Final
2020 Monitoring Report
Former Communications Site, Operable Unit 6

U.S. Army Garrison Alaska

HQAES No. 02871.1088
ADEC File No. 108.38.085
ADEC Hazard ID 4140

Graph 3-3 DRO Concentrations in Isolated Plumes MW62 and MW77

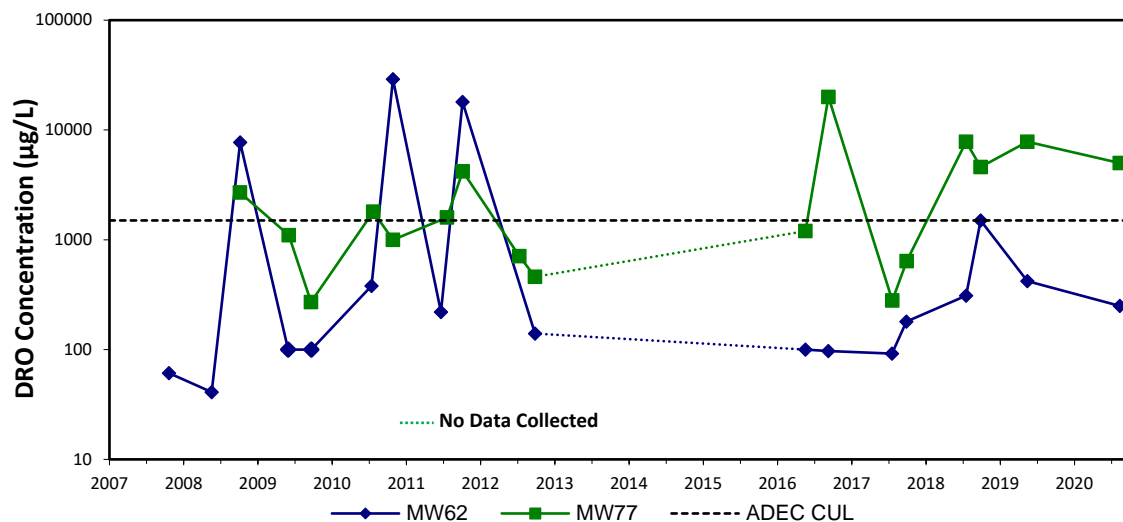
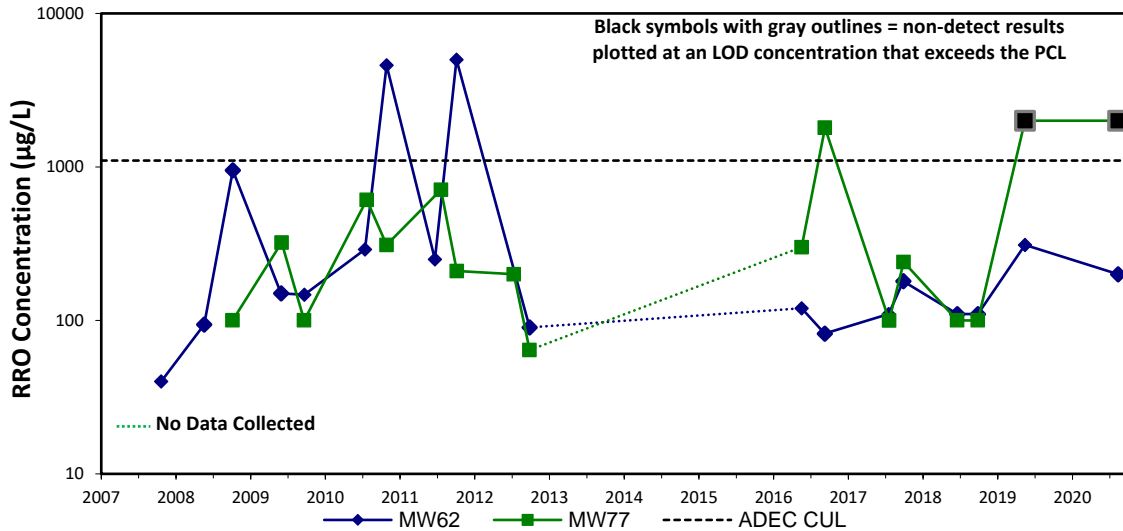
2	Section 3.2.2	In re-visiting the 2014 OU6 ROD, ADEC is curious why the two isolated DRO plumes are called out as "isolated" and with lower concentrations. What information is there that identifies these two isolated DRO plumes are not from the main source area? Couldn't the two isolated plumes be associated with the main plume? ADEC is asking this question for informational and clarifying purposes.	Noted	Remedial investigations (RIs) discovered multiple discontinuous source/release areas. It was determined that five groundwater plumes (main DRO plume, two isolated DRO plumes, TCP plume, and TCE plume) existed and this determination was accepted in the 2014 ROD, the 2015 RD/RA Plan, and the 2016 Fourth Five-Year Review by all parties, including ADEC. If ADEC has concerns about the five groundwater plume determinations, please address these concerns during the 2021 Five-Year Review.	Agree. ADEC will raise any concerns about the five groundwater plume determination in the forthcoming 2021 Five-Year Review.

FIGURE:
2-1

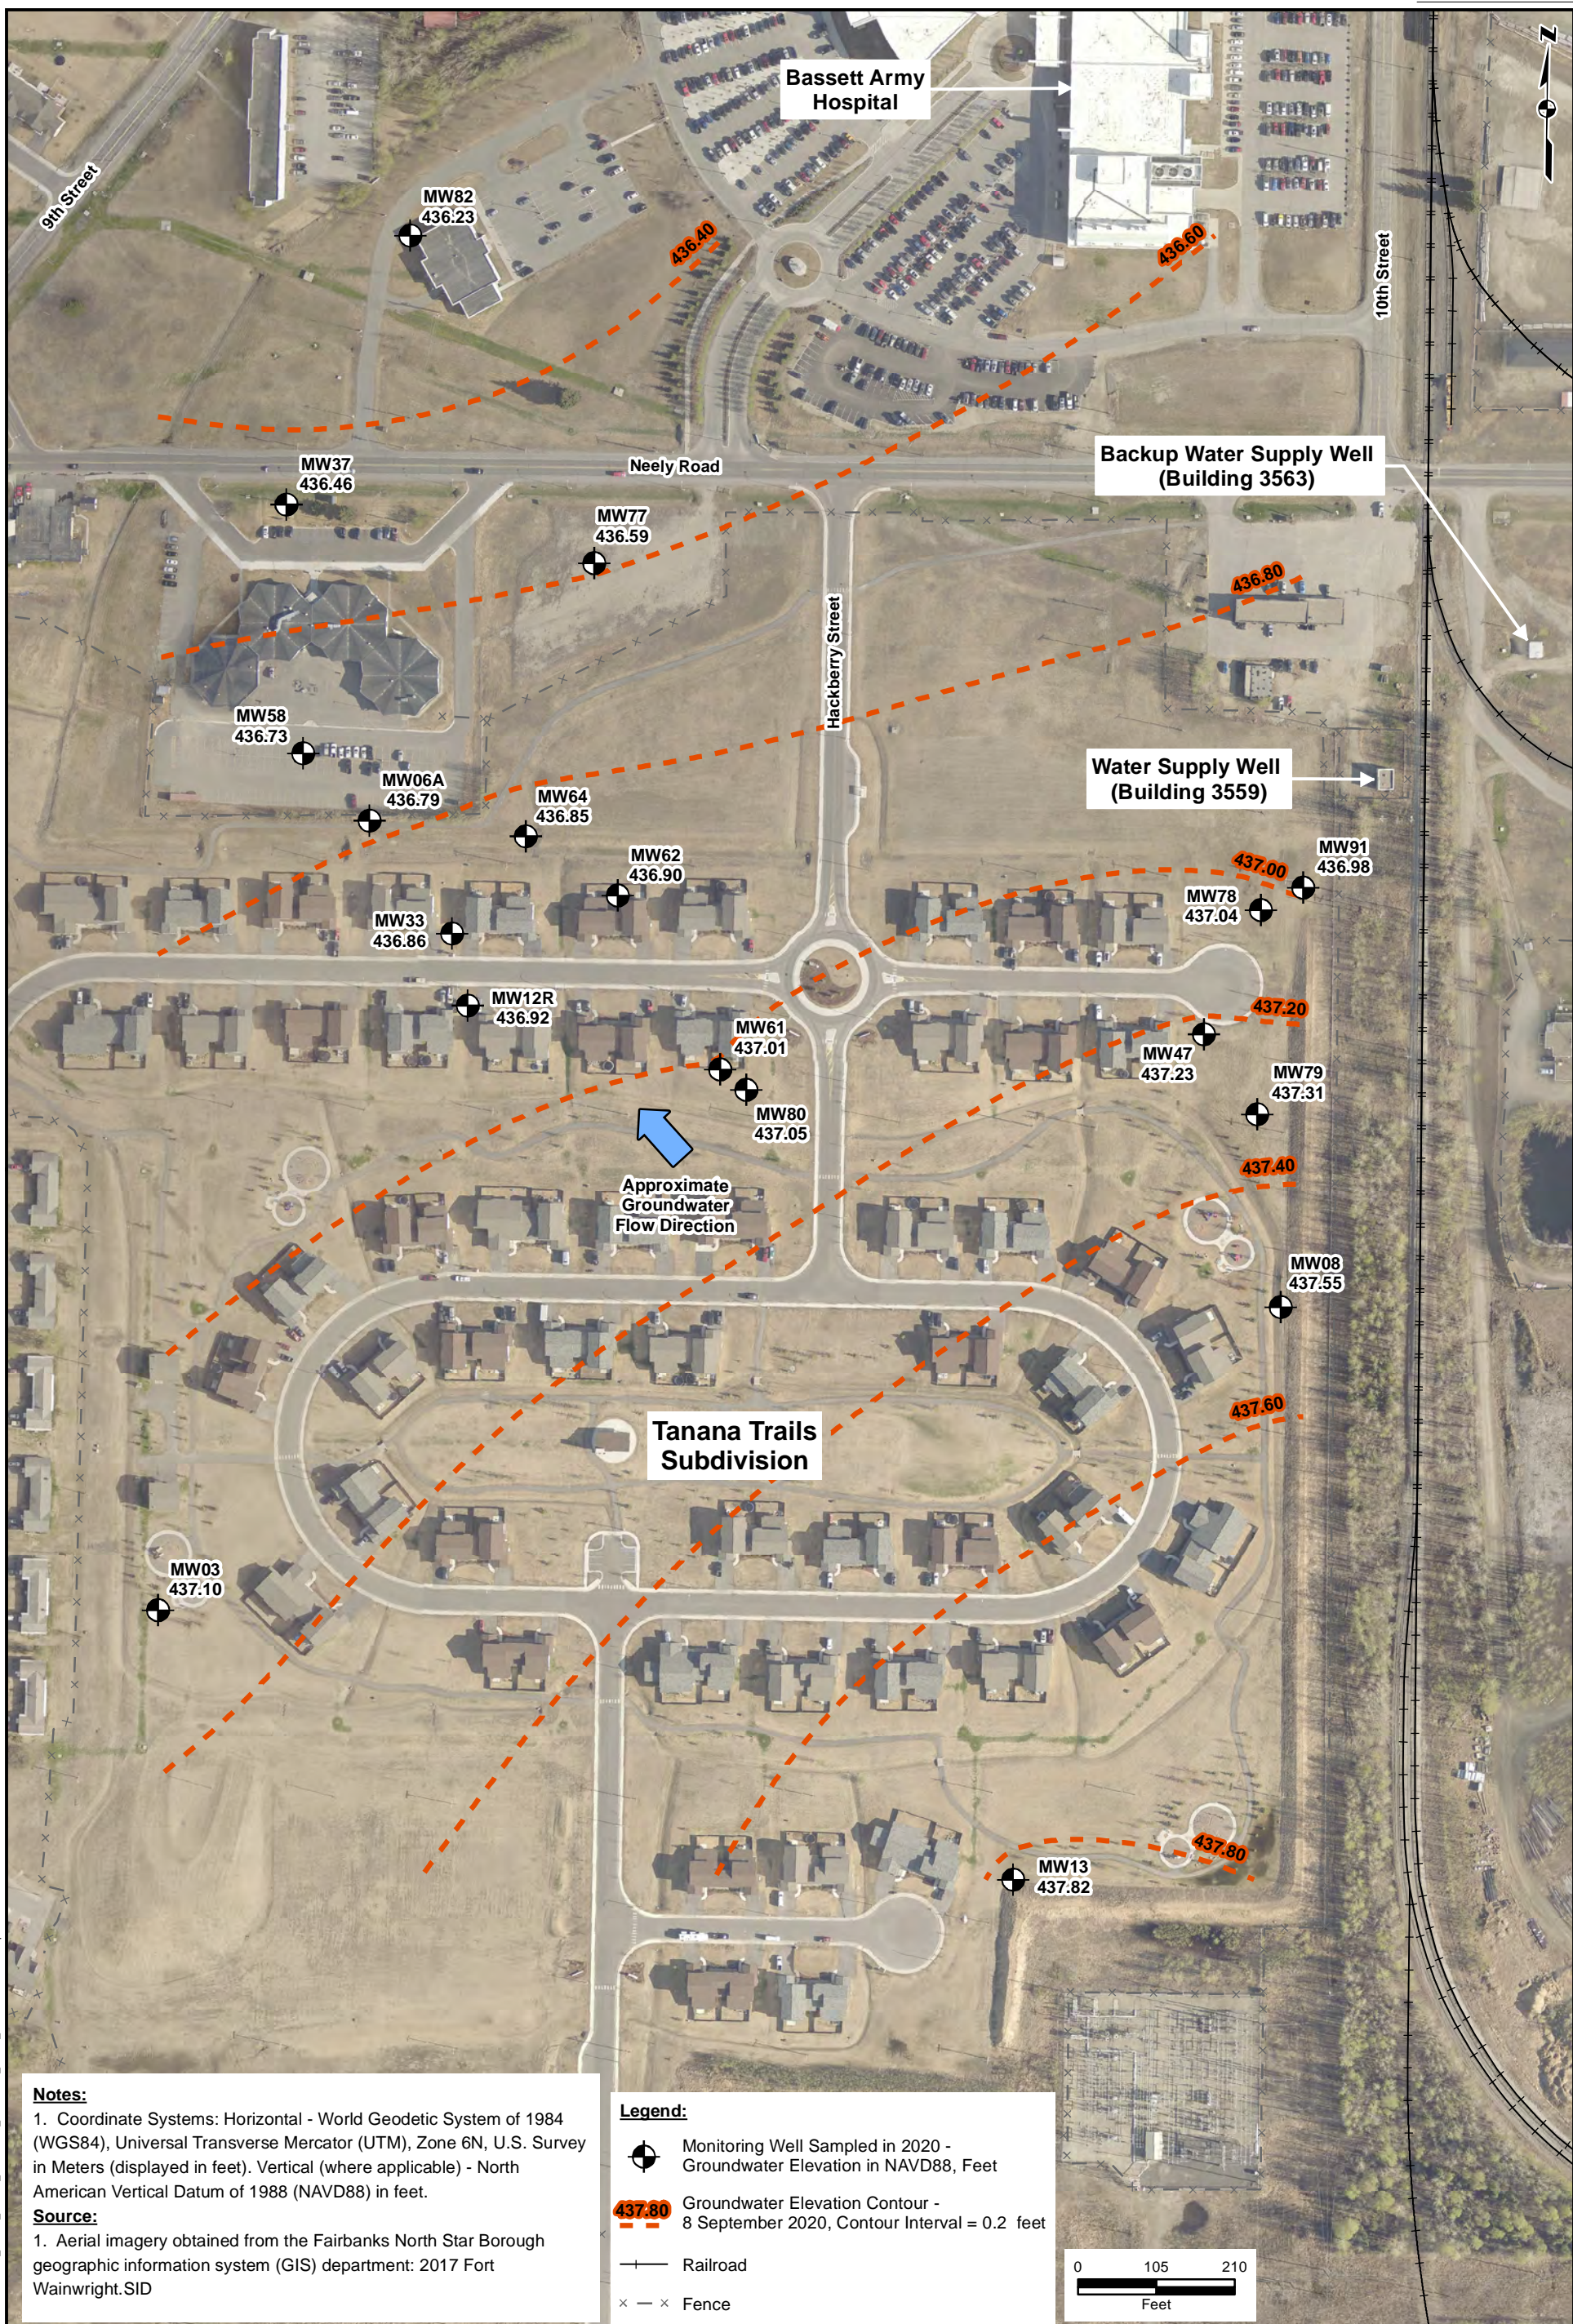
6	Figure 2-1	In looking at this figure, the groundwater gradient arrow points to the northwest. ADEC has reviewed site information on the four wells removed from the sampling program in 2019 and recommends adding three of those four wells back in at a reduced frequency (MW-35, MW-32R and MW-48) to continue to verify the plume will not or has not expanded in those directions.	Noted	The Army will continue to monitor groundwater contaminant plumes at this site. Adding wells MW-32R, MW-35, and MW-48 back into the sampling program, at a reduced frequency, may be considered in the future.	Agree.	
7	Appendix B CDQR and ADEC Laboratory Data Review Checklists, Section 3.2	Statement: "Impact to the project is likely negligible as free project...." Typo, free project should be 'free product.' Please correct.	A	The typo will be corrected, as suggested.	Agree with comment backcheck.	
8		--End of Comments--		Thank you!

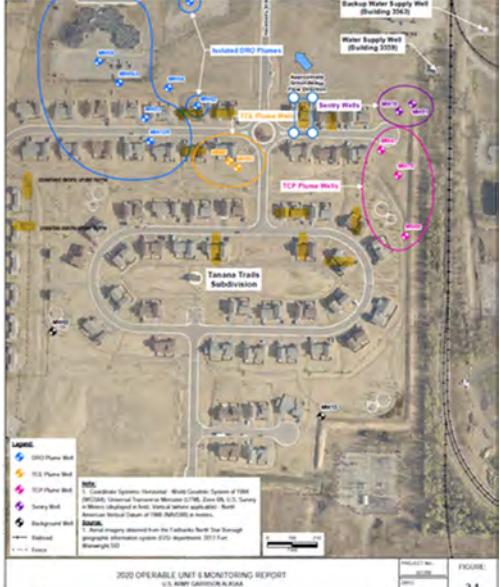
2.	1.3.3 and Figure 2-1		<p>Consider including a sentence that describes the debris remaining at the site. Fig A-22 of the ROD has housing units with debris observed under house foundations (Bldgs 15, 17, 22, 24, and 48) and buildings with possible debris under the foundation (Bldg 1, 11, 12, 13, 21, and 25).</p>	<p>Accepted. The ROD states that minor amounts of metal debris remain beneath several buildings, but that the presence of such materials is not a direct indication that chemical contamination is present. Only a few locations had limited volumes of contaminated soil associated with the subsurface debris. In addition, sub-slab soil gas sampling conducted at the residences did not provide evidence of significant soil contamination. Section 1.3.3</p>

Number	Page	Section	Comment	
			<p>I've marked up Figure 2-1 to show where the observed and possible debris under homes is located in relation to existing plumes. It seems pertinent to include this in the monitoring reports, especially if a significant seismic or other disturbance occurs at the site in the future.</p>	<p>will be revised to include this information regarding the remaining debris at OU6, and the impacted buildings will be identified on Figure 2-1.</p>

3.		<p>Figure 2-1 with observed and possible debris beneath foundations</p>	 <p>Vertical highlight is observed debris; horizontal highlight is possible debris.</p>	<p>Accepted. Figure 2-1 will be revised to identify the highlighted buildings. Also see response to Comment #2.</p>
